RHODE ISLAND DEPARTMENT OF TRANSPORTATION

1R Improvements to Rt. 107

NOTICE TO PROSPECTIVE BIDDERS

ADDENDUM NO. 2 Prospective bidders and all concerned are hereby notified of the following changes in the Plans, Specifications, Proposal and Distribution of Quantities for this contract. These changes shall be incorporated in the Plans, Specifications, Proposal and Distribution of Quantities, and shall become an integral part of the Contract Documents.

SIGNING AND STRIPING
 PLAN NO. 1

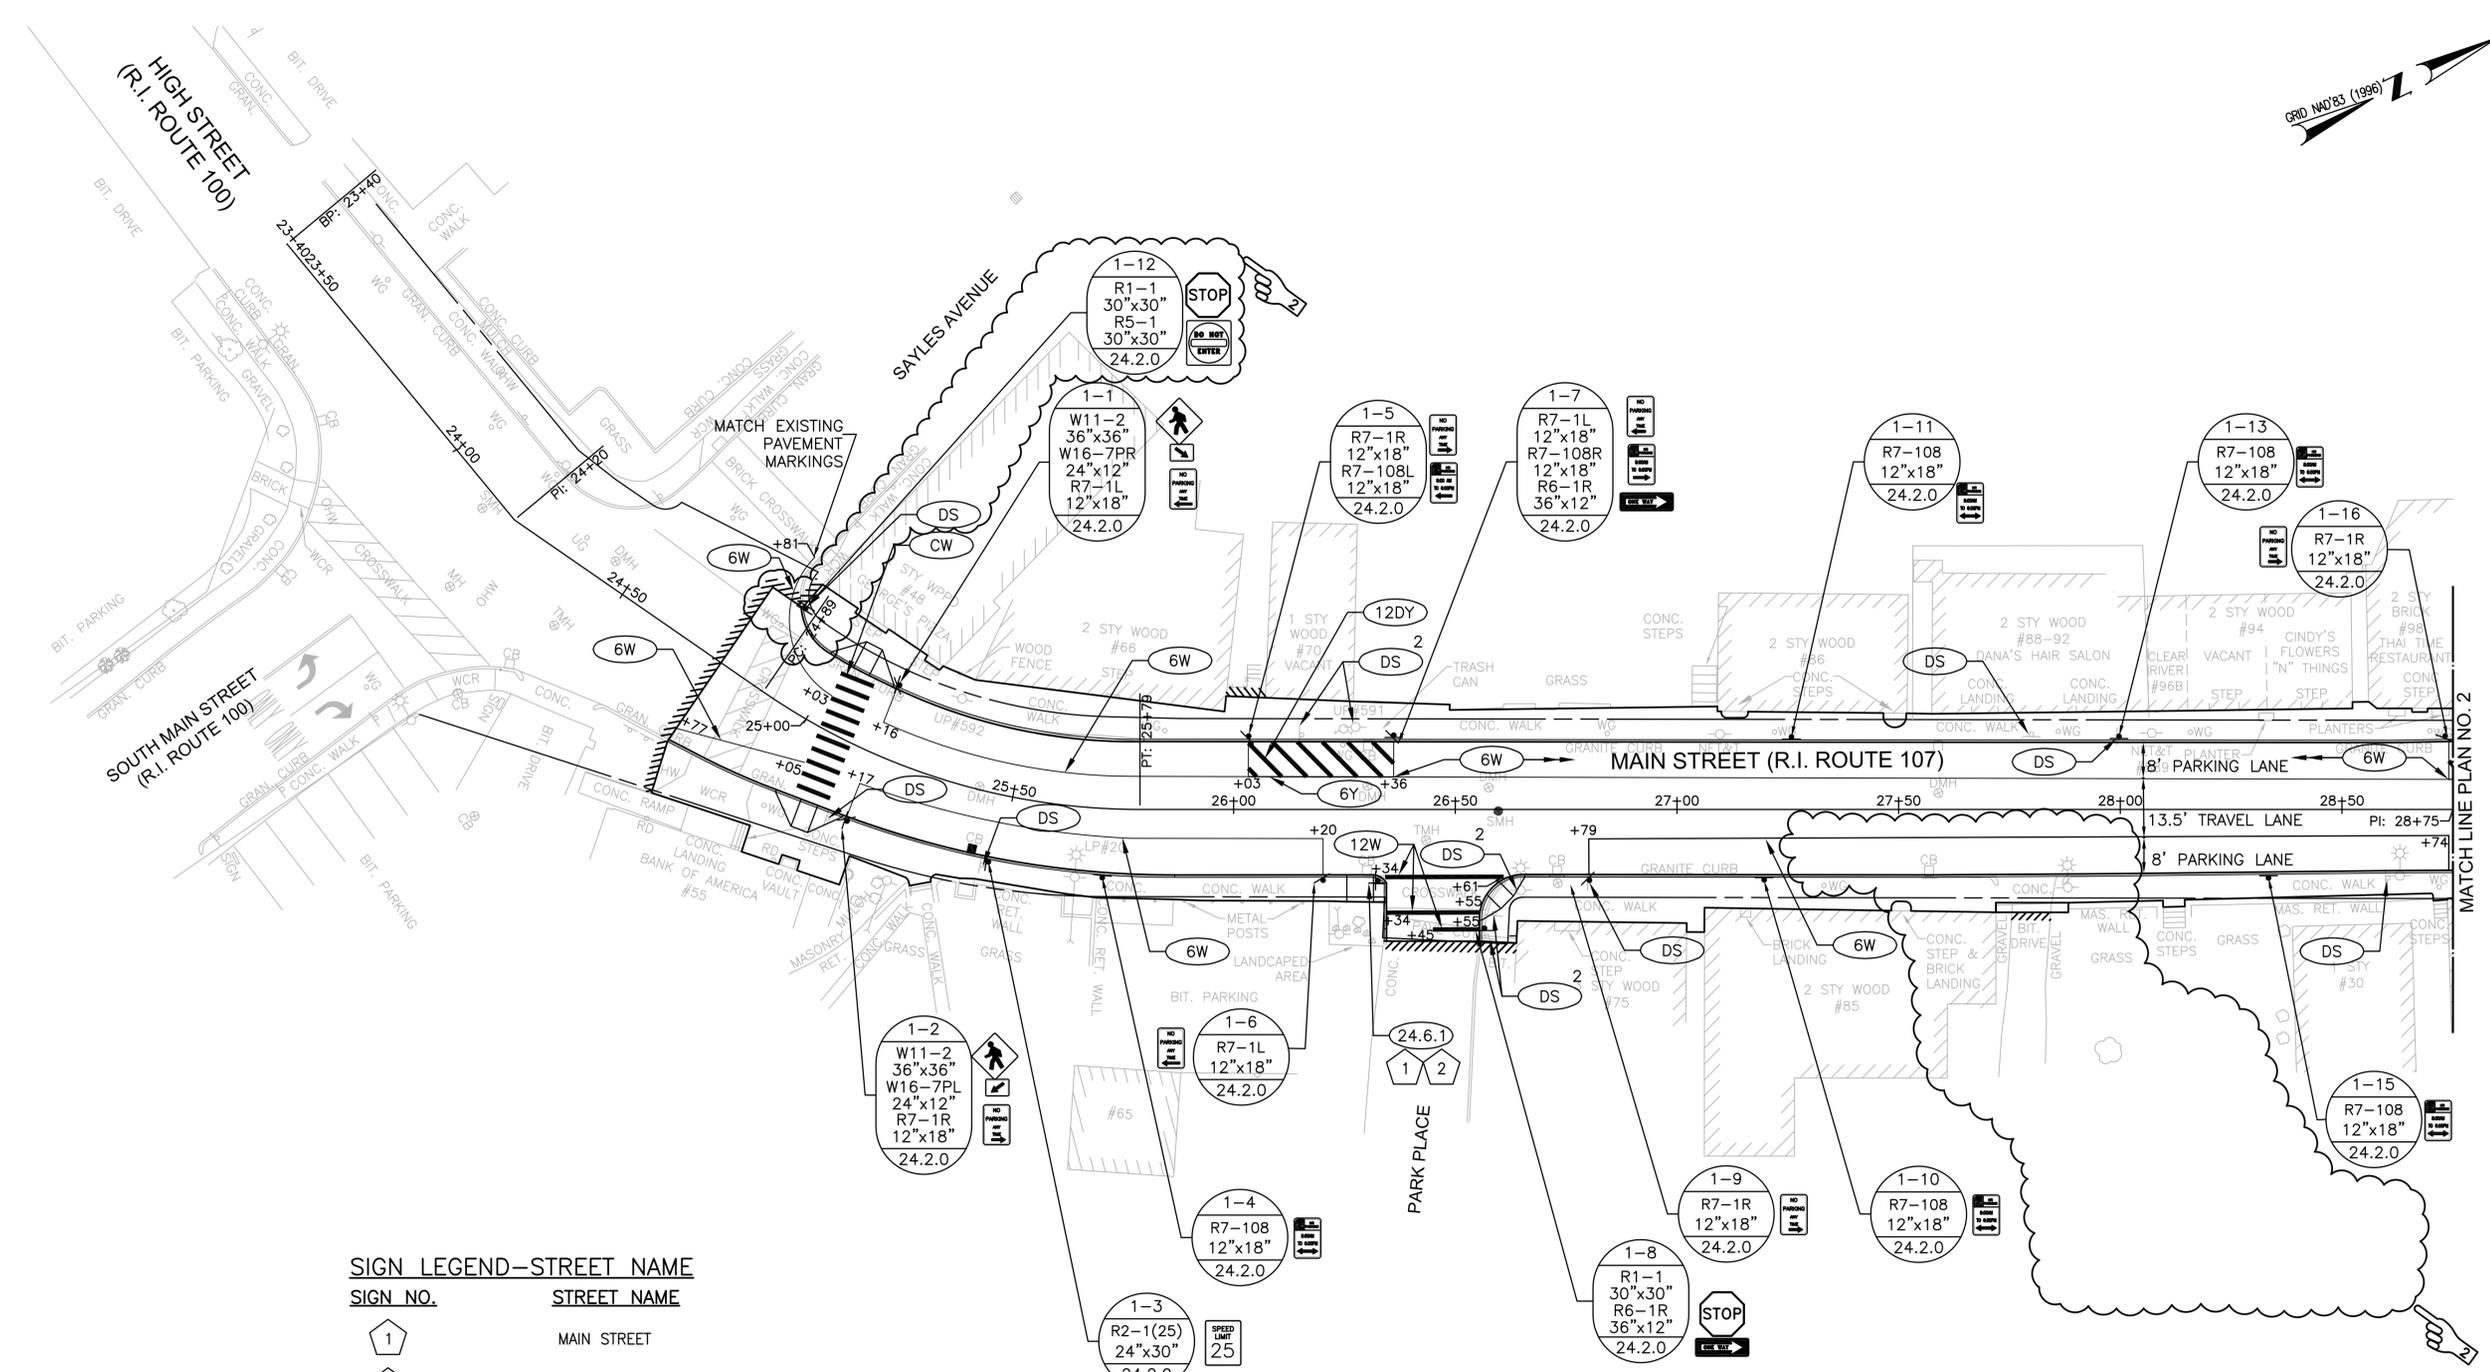
5. SHEET NO. 23 - SIGNING AND STRIPING NO. 1
Delete Sheet No. 23 - Signing and Striping No. 1 in its entirety and replace it with Sheet No. 23 - Signing and Striping No. 1 (R-1) attached to this Addendum No. 2. Sidewalk limits near Sayles Avenue have been revised, a driveway has been removed and signs have been deleted and added.

SIGNING AND STRIPING
PLAN NO. 2

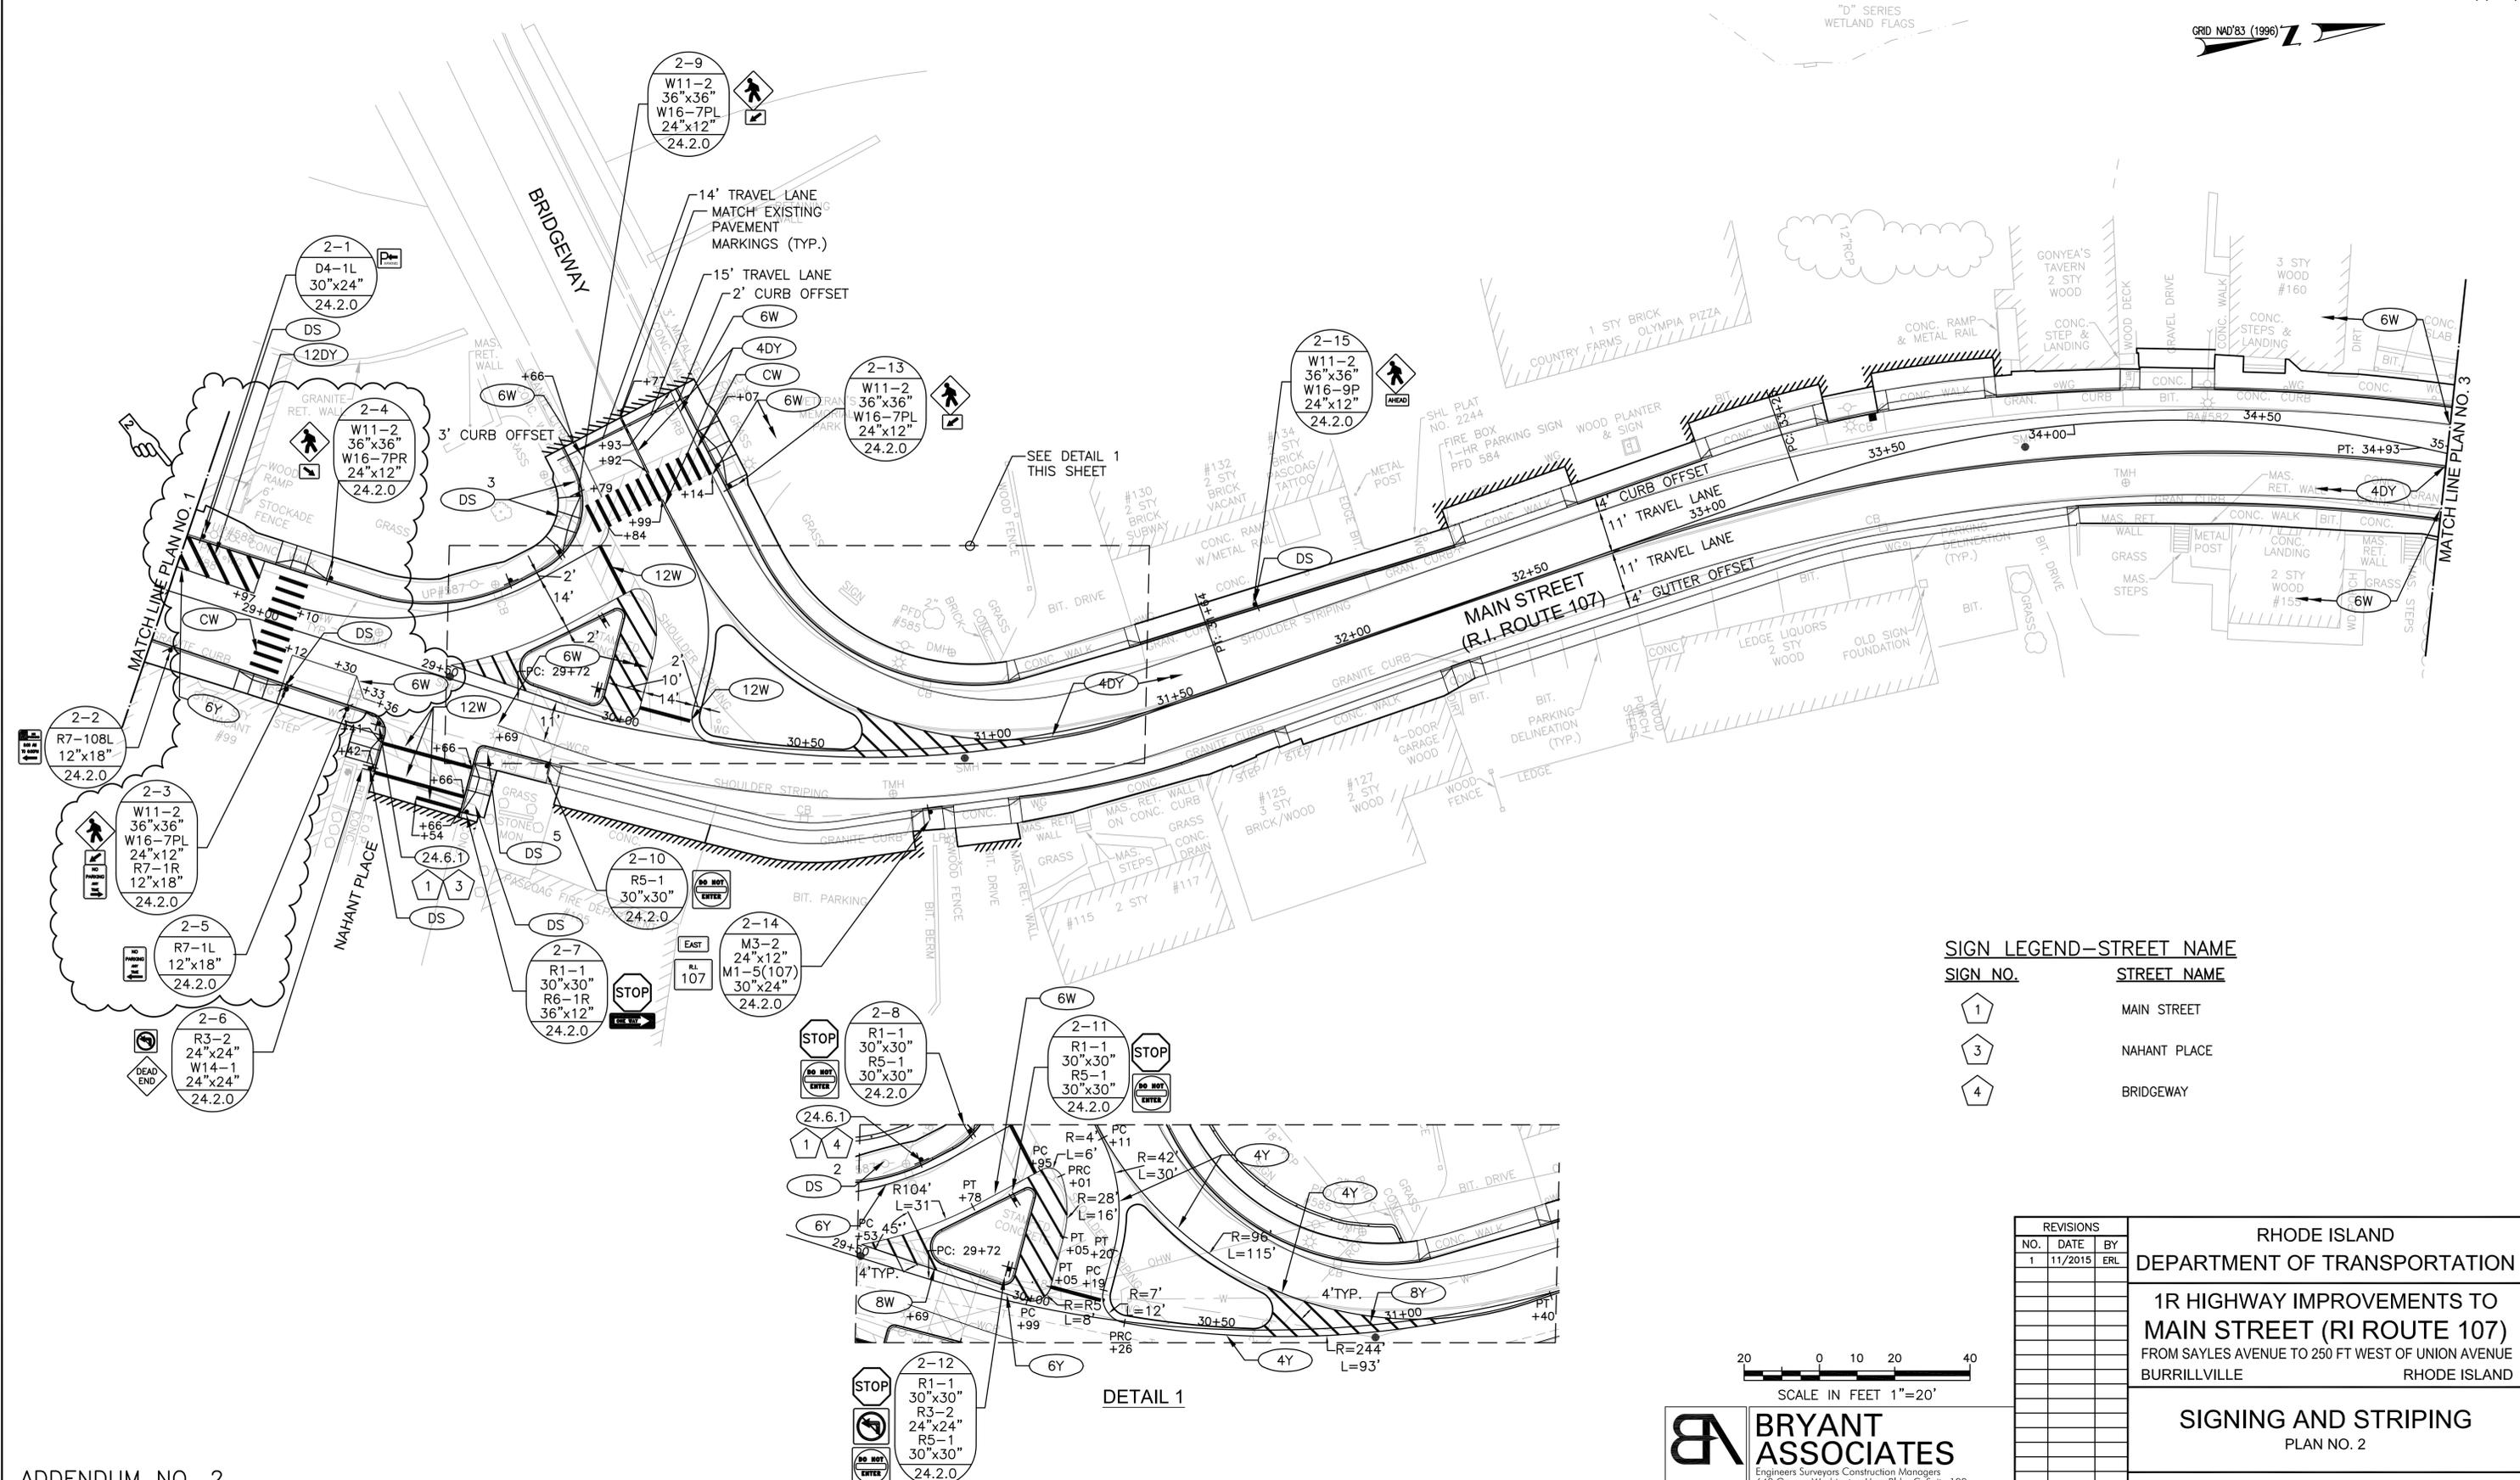
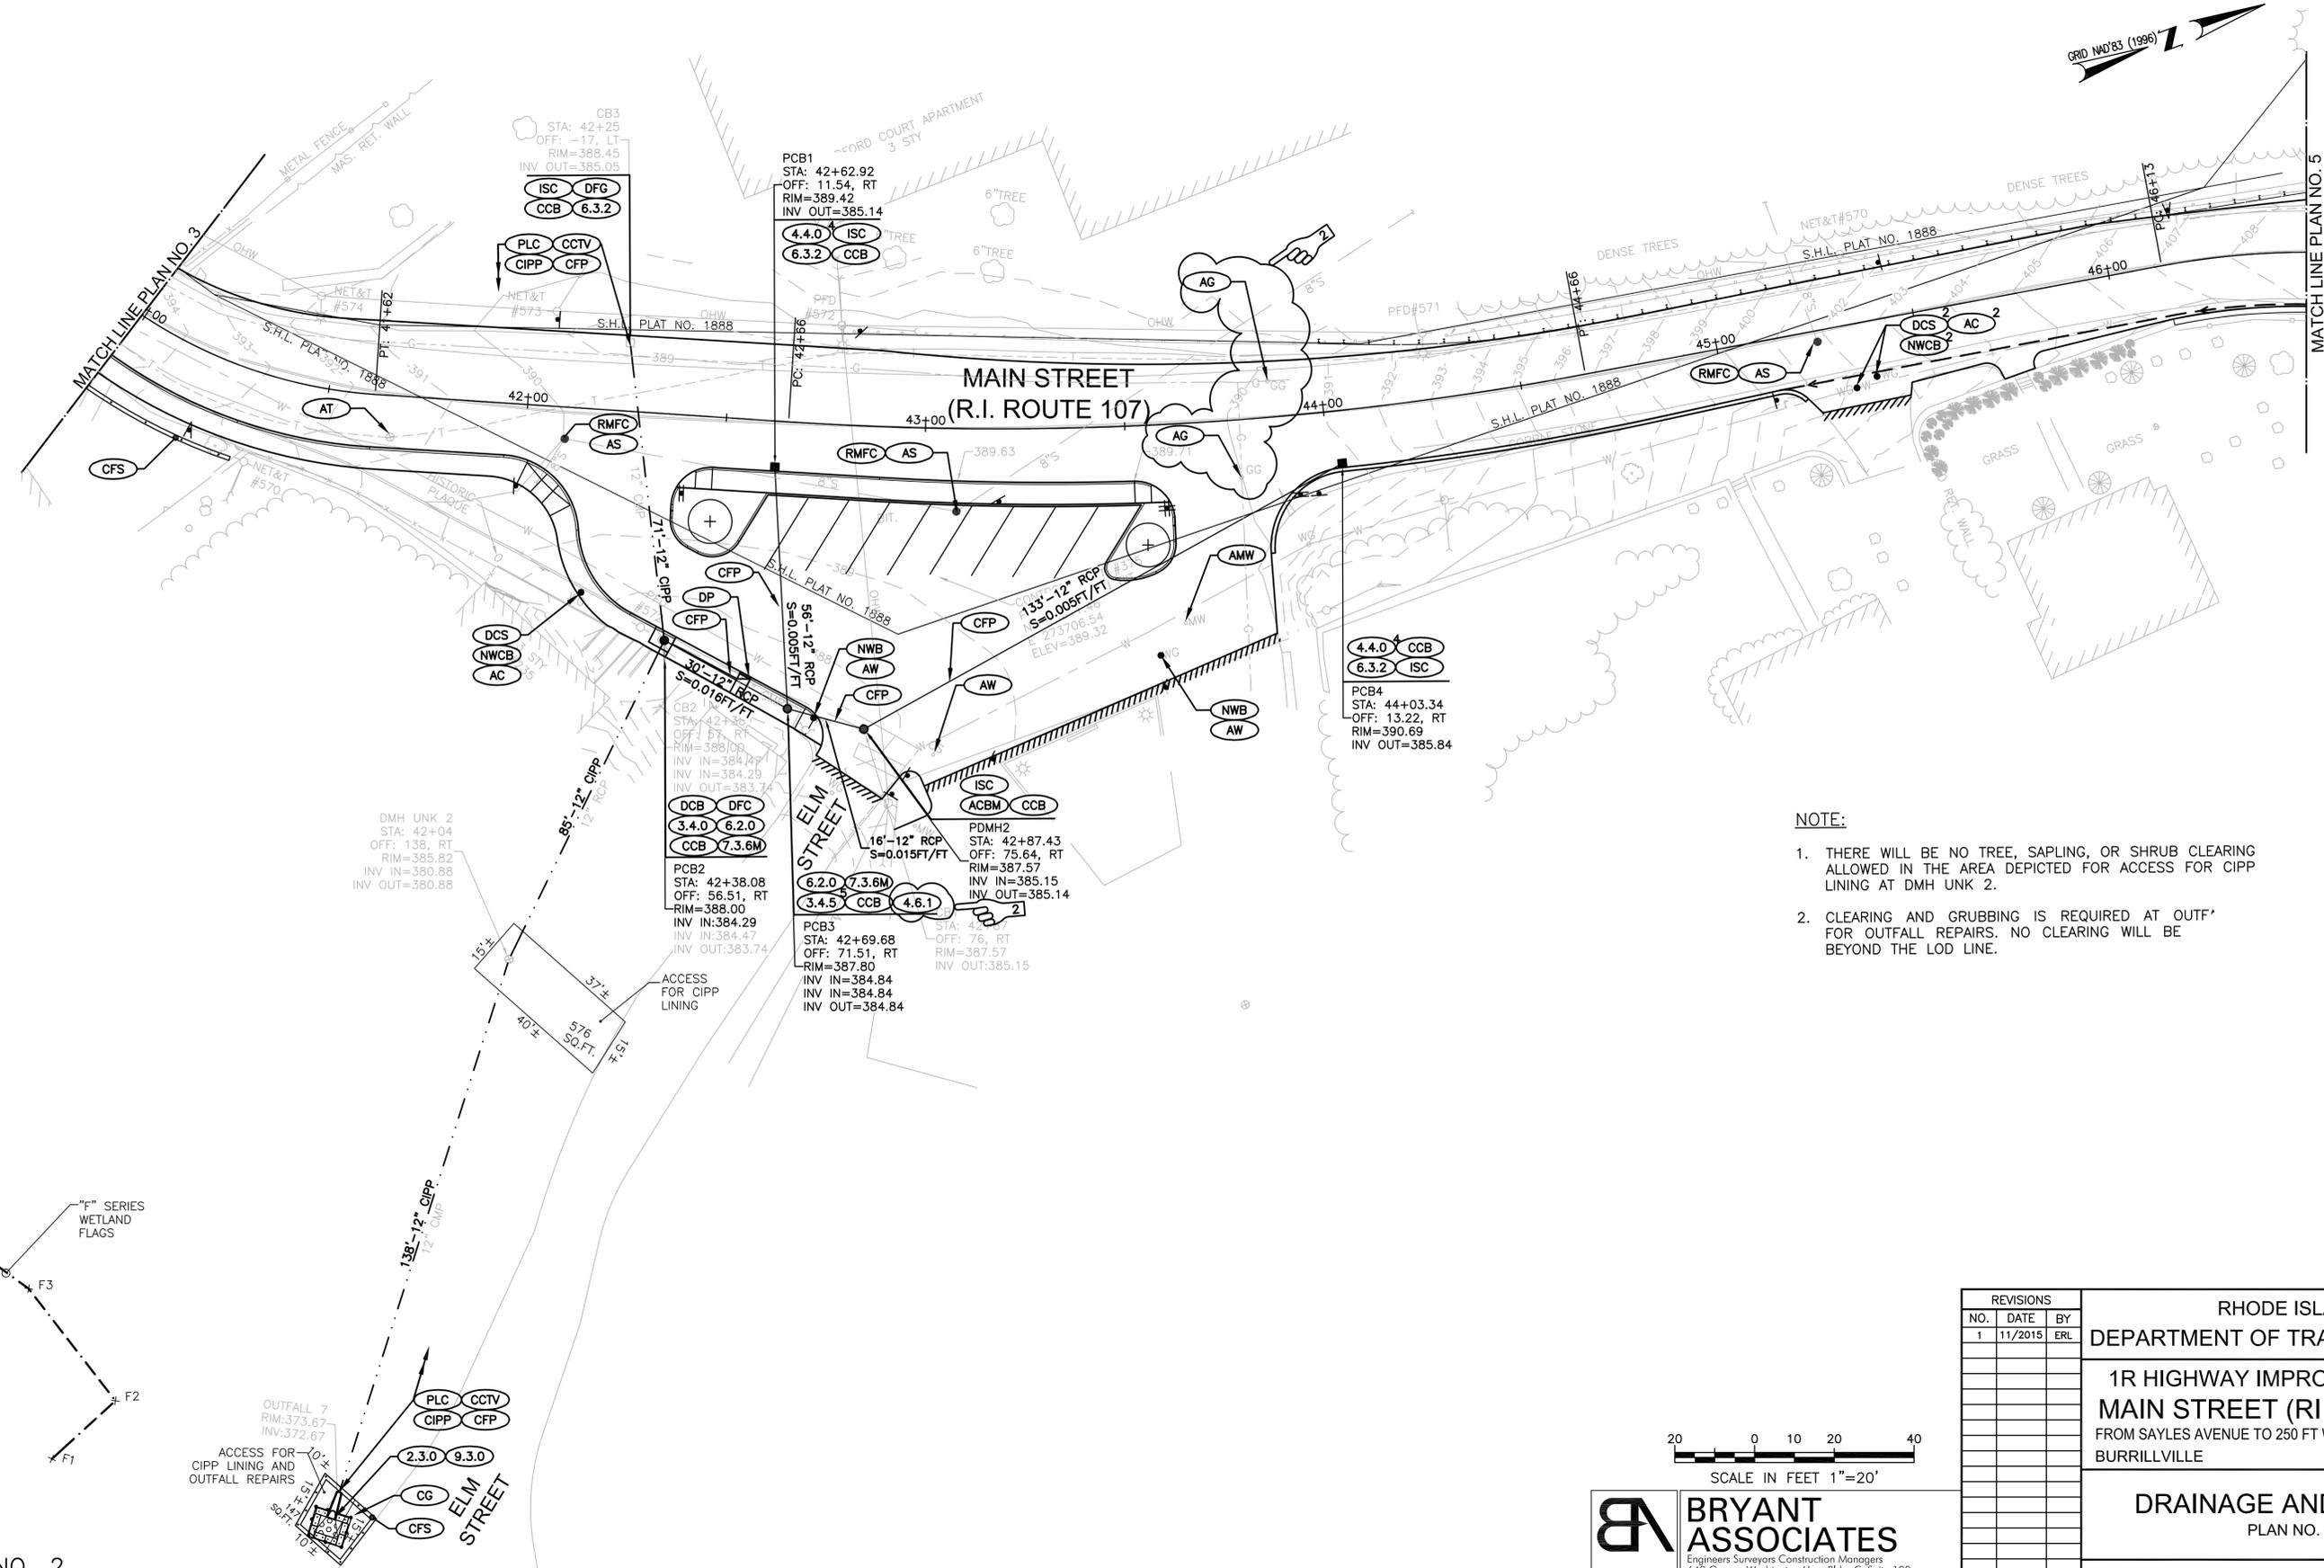
6. SHEET NO. 24 - SIGNING AND STRIPING NO. 2
Delete Sheet No. 24 - Signing and Striping No. 2 in its entirety and replace it with Sheet No. 24 - Signing and Striping No. 2 (R-1) attached to this Addendum No. 2. Curb ramps and sign locations have been revised.
